**CONSENT DECREE AND ORDER AS TO  
CAMPBELL UNION 76, HEDIA  
PETROLEUM INC. AND BOZORGHADAD  
TRUST ONLY**

Union 76 - 3145 S. Bascom. - Campbell, CA

Disabled Access Evaluation: Inventory of Architectural Barriers

**Union 76  
Campbell, CA  
DRAWING 01**

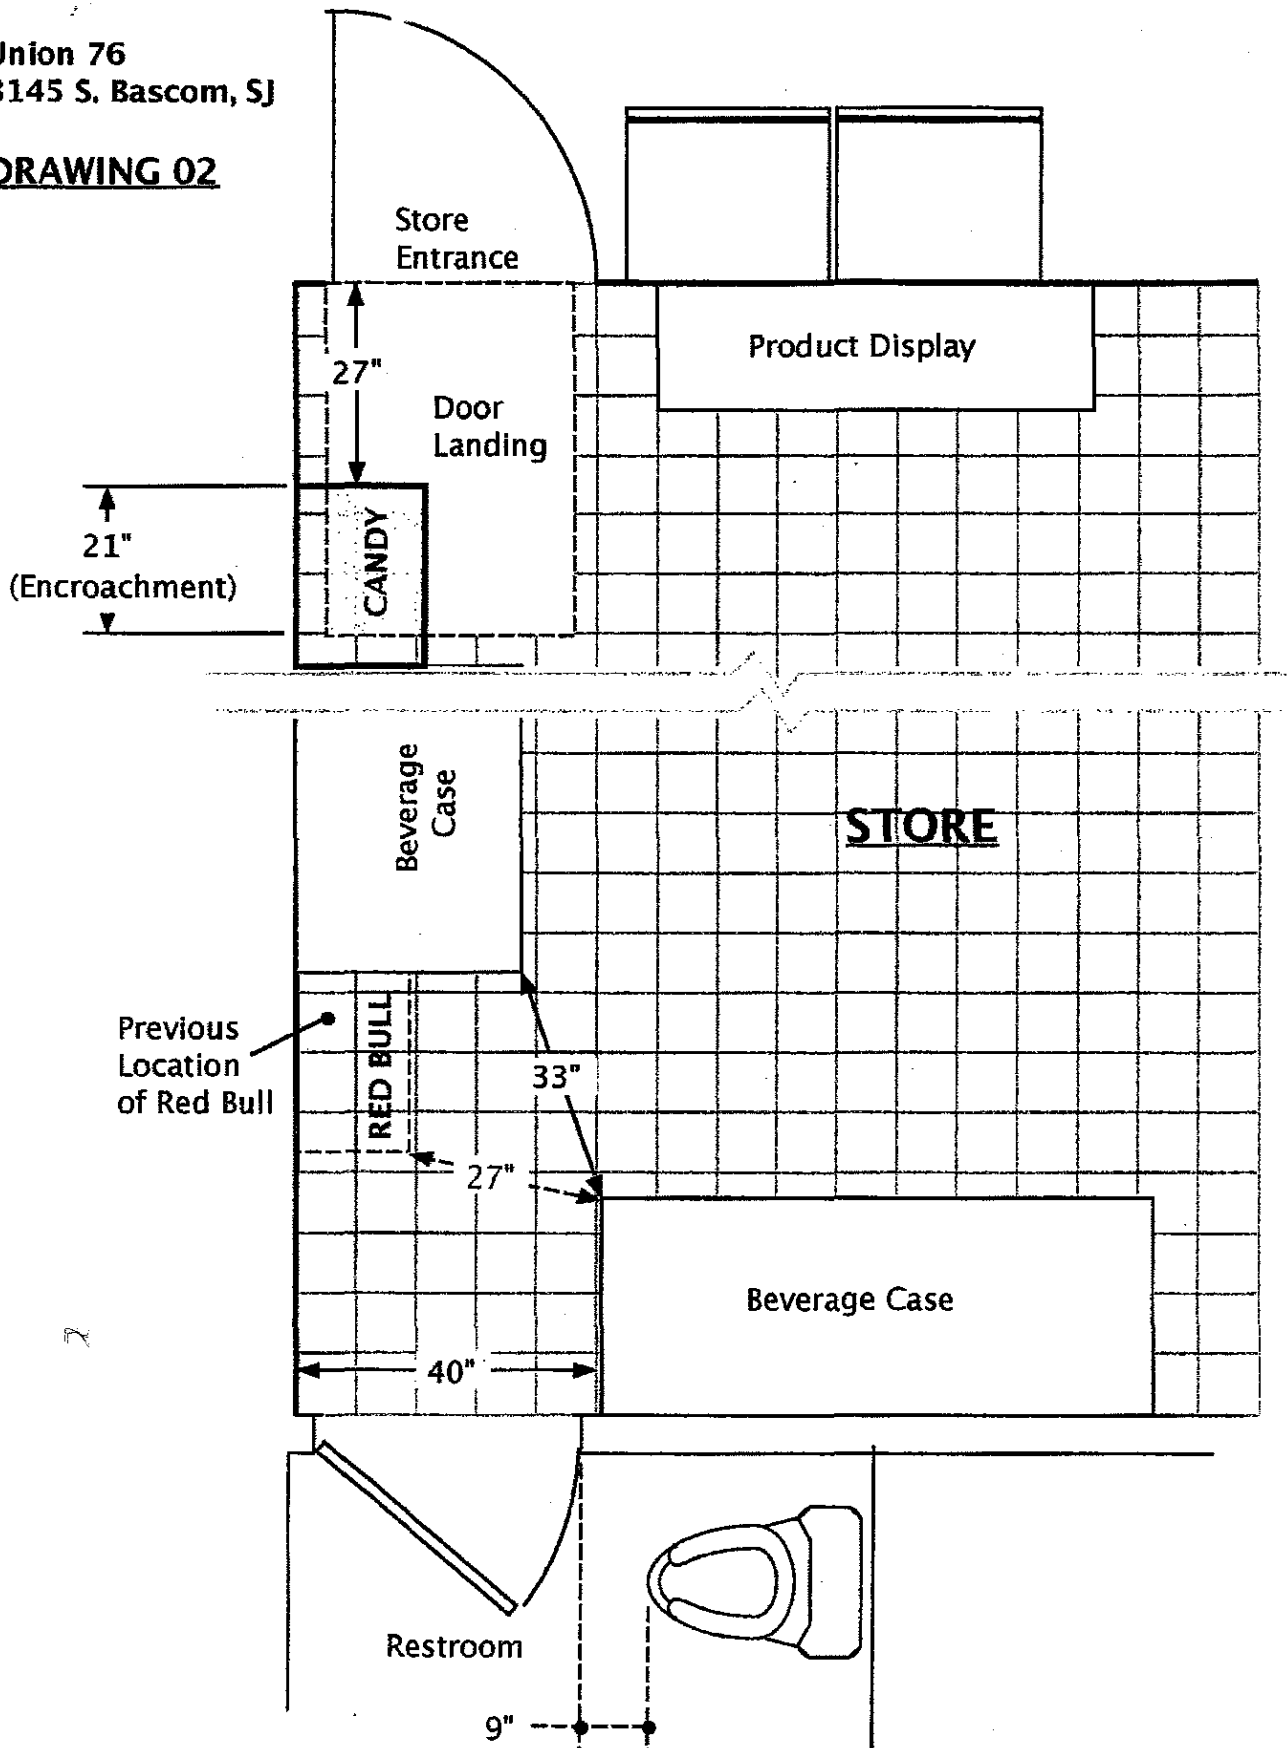
**Route from  
Parking to Store**

**EXISTING**

- a) Curb ramp encroaches into access aisle
- b) Route around entry door is 42" wide

**RECOMMENDATION**

- a) Remove the curb ramp and rebuild the 4% sloped section of walkway more steeply in order to descend to the level of the parking lot.
- b) Reverse the swing of the entry door.

**DRAWING 02**

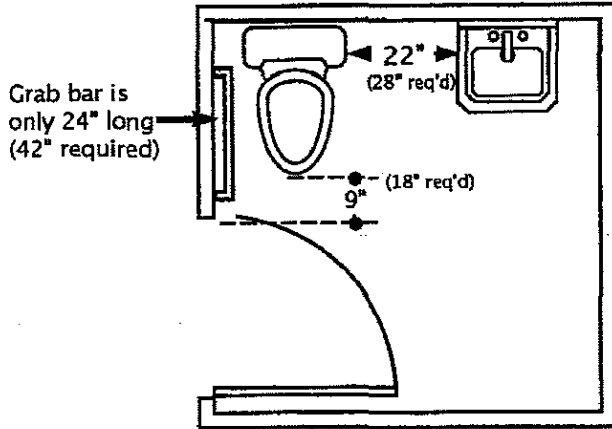
#	Barrier Description	Requirement	Code	Recommendation	Graphic
6	<p><b>Entry Door - Interior Side</b> A candy display on the east wall of the store is <u>only 27-in. from the face of the door</u> in its closed position. It therefore encroaches 21-in into the prescribed clear area of the door landing</p> <p><i>Note: The candy display also prevents the door from fully opening 90-degrees, resulting in a clear path that is <u>only 27-in. wide when the door is swung in.</u></i></p>	<p>The level area must have a clear length opposite the direction of door swing (i.e. the "push-side") of 48 inches.</p> <p>When a door is open 90-degrees there must be a clear opening at <u>least 32-in. wide</u></p>	<p>4.13.6 1133B.2.4.2</p> <p>4.13.5</p>	Remove the product display and maintain a clear 48" deep landing on the interior side of the door.	<p>Photo 05 (encroachment)</p> <p>DWG 2 (Door opens only part way)</p>

**DRAWING 03**

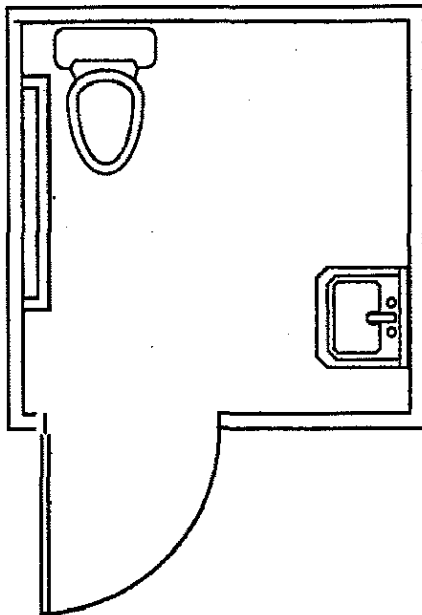
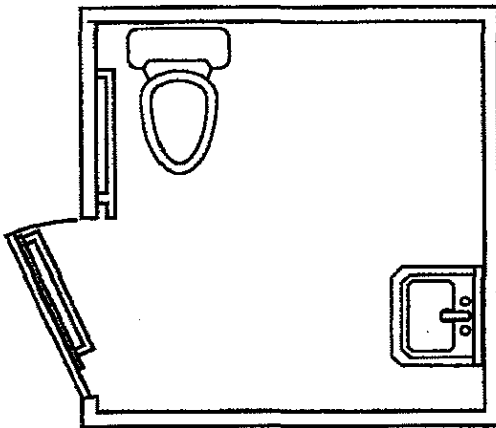
9	<p><b>Strike-Edge Clearance</b> The clear floor area of the door landing is limited by the proximity of the toilet. The door landing therefore extends only 9-1/2"</p>	On the side toward which an interior door swings, 18" of clear space is required beyond the strike-edge (latch side) of the door	4.13.6 1133B.2.4.	<p>Perform either A or B:</p> <p>A) Install a power door opener</p> <p>B) Relocate the door to the east wall (exterior wall) where</p>	<p>Photo 07</p> <p>DWG 03</p>

**EXISTING CONDITIONS**

**RECOMMENDATION-A**

- Move lavatory to create side-transfer space
- Install power door opener to mitigate the lack of strike-edge clearance.
- Add grab to inside of door

**RECOMMENDATION -B**

- Move lavatory to create side-transfer space
- Relocate door to allow full-length grab bar and to provide required strike-edge clearance on the pull-side of the door.
